Applicant : BROWN, RICHARD Page 9
Serial Number : 10/690,808
Amendment in Response to Office Action of 07/18/2005

REMARKS

Annotated Drawing Showing Amendments in Red

FIG 7

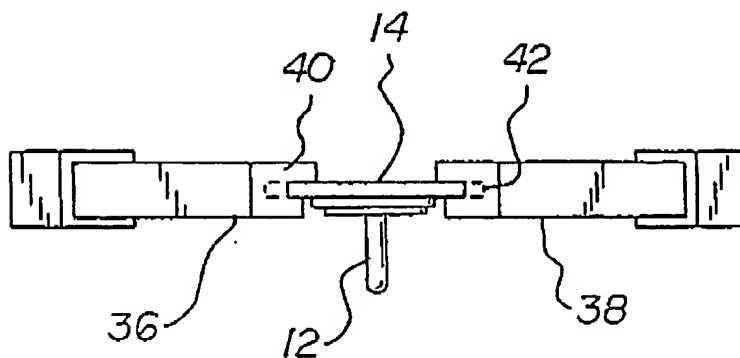
Lastly, the drawings have been amended herein by the elimination to Figure 8 directed to the drive shaft providing the motion and timing to the air cylinder. The specification has been amended beginning at Page 9, Line 13 by deleting the paragraph relating to Figure 8.
